UNITED STATES
NUCLEAR REGULATORY COMMISSION
WASHINGTON, D.C. 20555-0001

SAFETY EVALUATION BY THE OFFICE OF NUCLEAR REACTOR REGULATION
RELATED TO AMENDMENT NO. 123 TO FACILITY OPERATING LICENSE NO. NPF-21
WASHINGTON PUBLIC POWER SUPPLY SYSTEM
NUCLEAR PROJECT NO. 2
DOCKET NO. 50-397

Figure 1. NUMAC-LRM functional block diagram

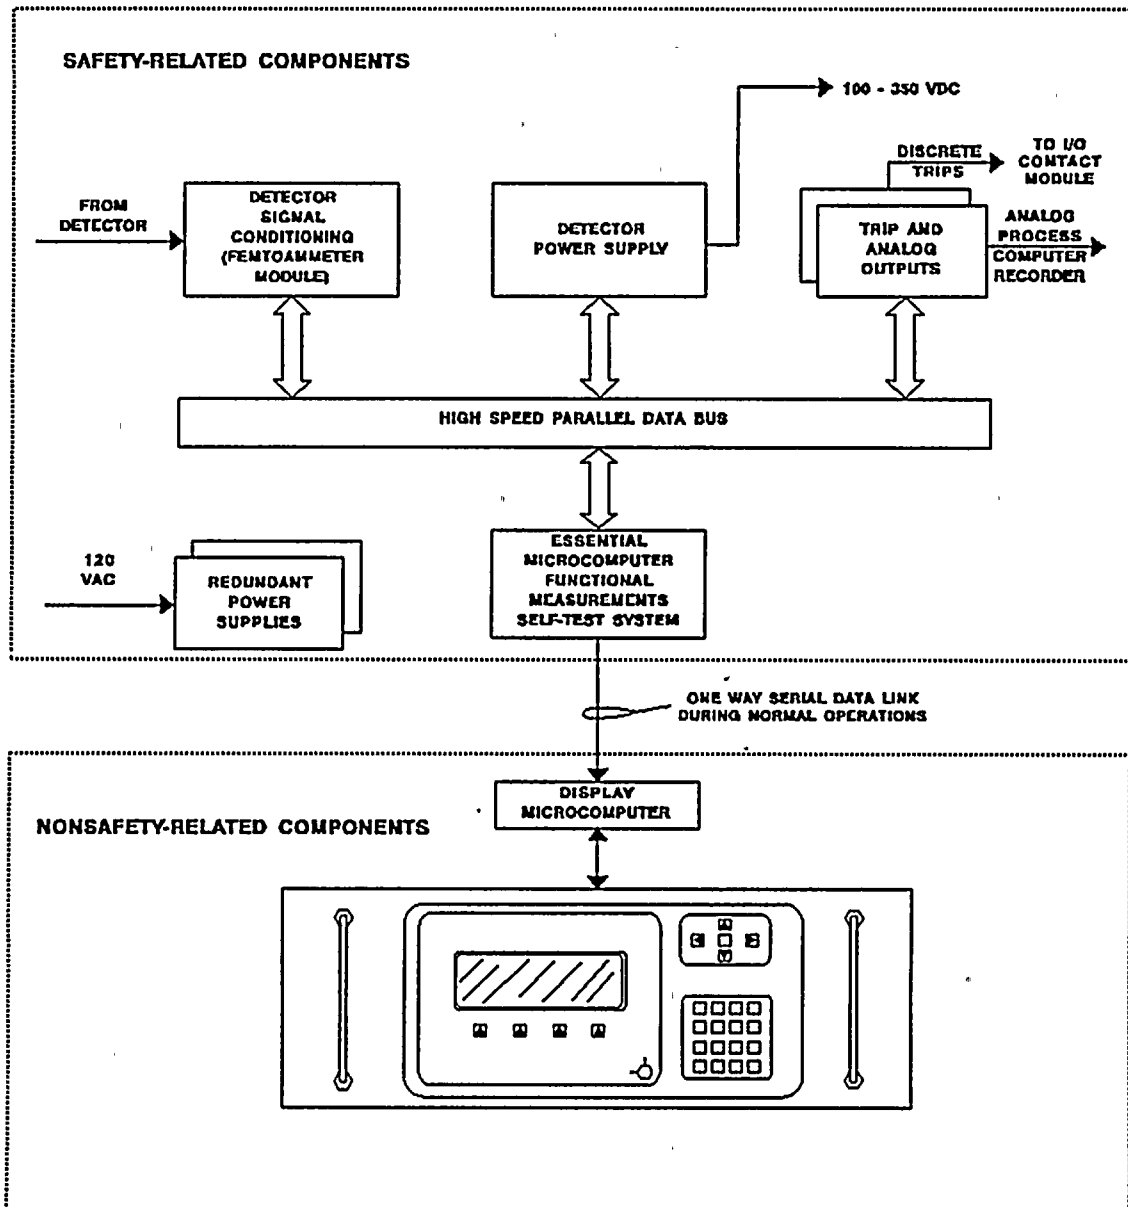
Figure 1 shows a NUMAC-LRM functional block diagram. The safety-related

portion of the NUMAC-LRM consists of four channels of the following components:

- detector signal conditioning (femtoammeter module)
- detector power supply
- trip and analog outputs
- high speed parallel data bus
- essential microcomputer functional measurements self-test system
- serial data link
- Class 1E redundant 120 Vac power supplies
